VEHICLES AFFECTED: The service bulletin applies to all vehicles manufactured before June 4th, 2009 which applied to any vehicle with VIN #442 and lower. Any bikes built after June 4th, 2009 with VIN # higher than VIN #443 already have this adjustment made to the vehicle from the factory.

KIT #- 90600010

Quantity	Part #	Description
1	71000002	Stud Mount Wire Harness Retention clip with 8" zip tie
1	70400054	washer
1	Wire Harness Routing II – Service Bulletin #007	Instructions for Wire Harness Routing II – Service Bulletin #007

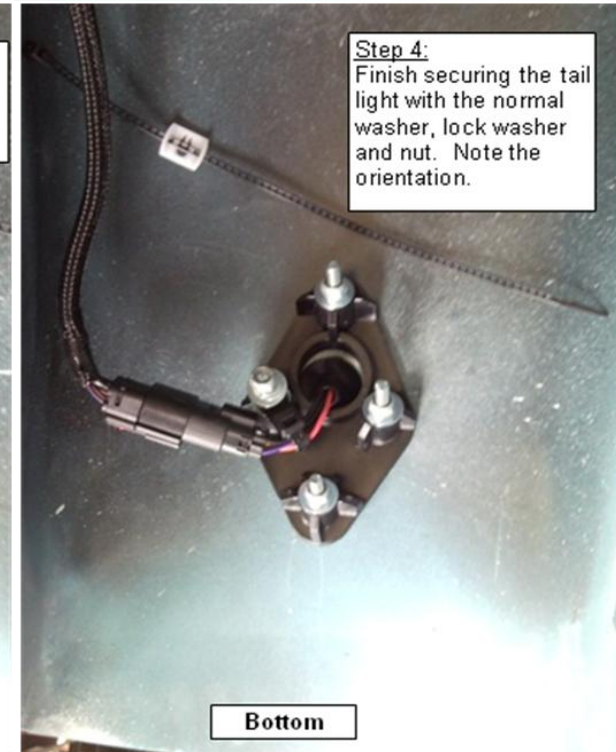
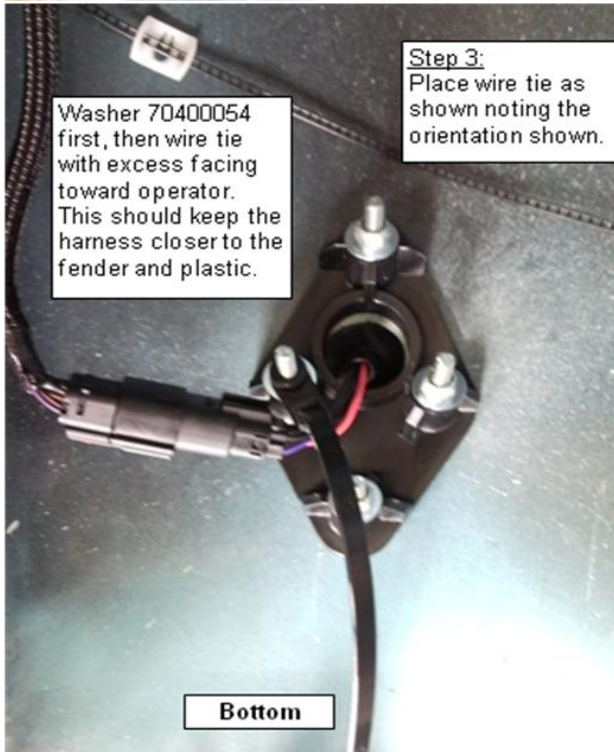
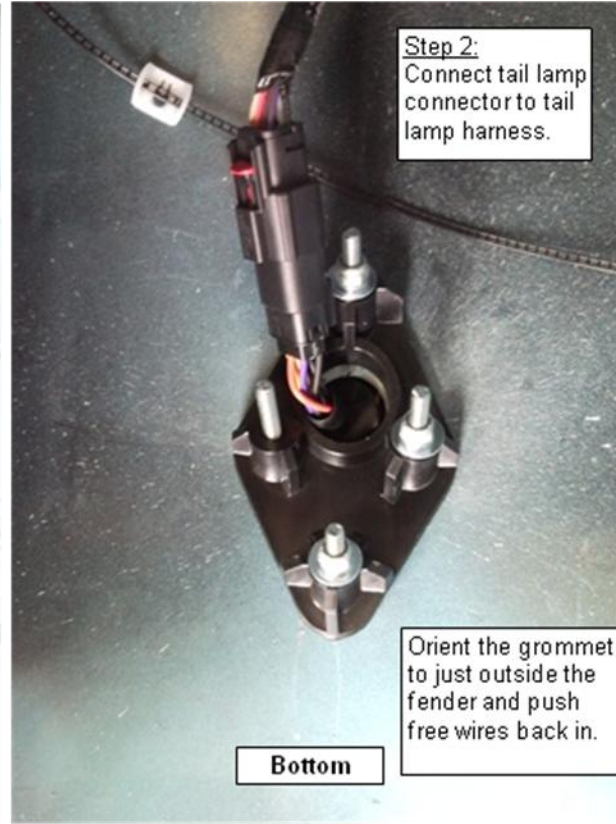
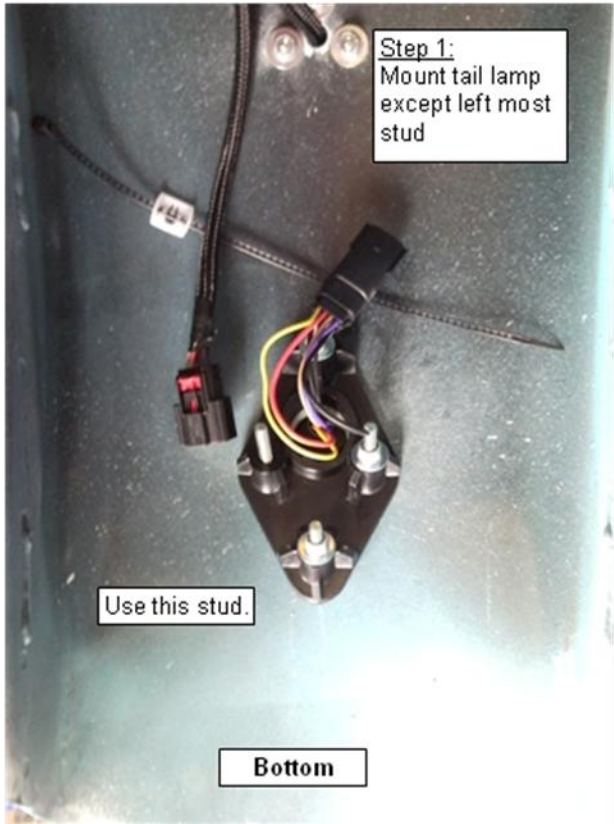
1. Remove the lower left tail light nut lock washer and flat washer from back of rear fender. *See figure 1*
2. Install washer (pn# 70400054) on stud. *See figure 1*
3. Connect tail lamp connector to tail harness if necessary. *See figure 2*
4. Install zip tie mount over washer and orientate to 5 o'clock position. *See Figure 3*
5. Cut zip tie and install washer, lock washer and nut removed in step 1. *See Figure 4*
6. Torque fastener to 70-90 inch lbs.
7. Secure harness as shown in figure 5.

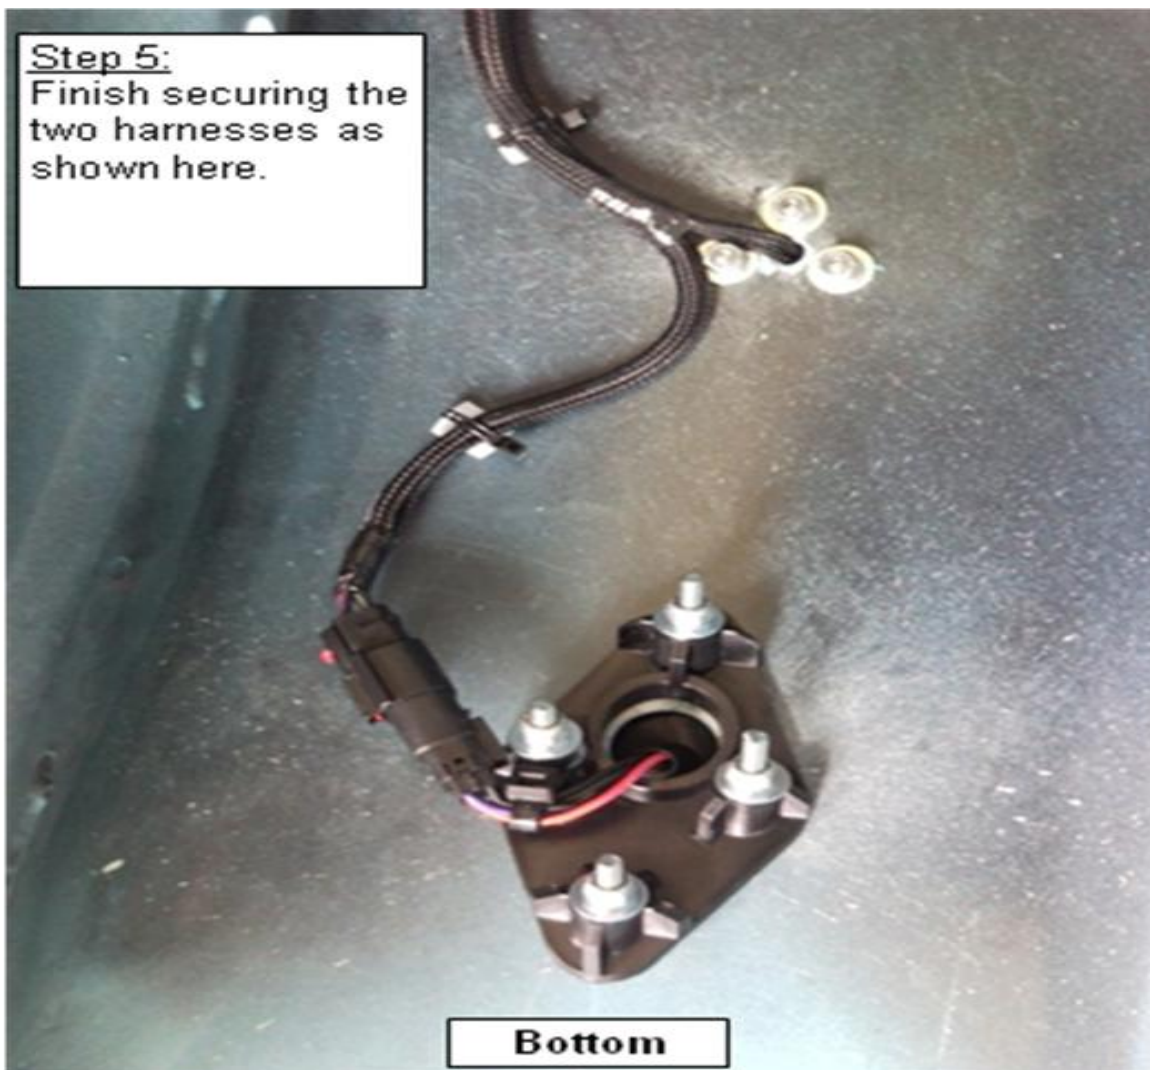
Note: Typical distance from back of connector to wire tie is 0.5inches - 1.5 inches.

Step 5:  
Finish securing the  
two harnesses as  
shown here.
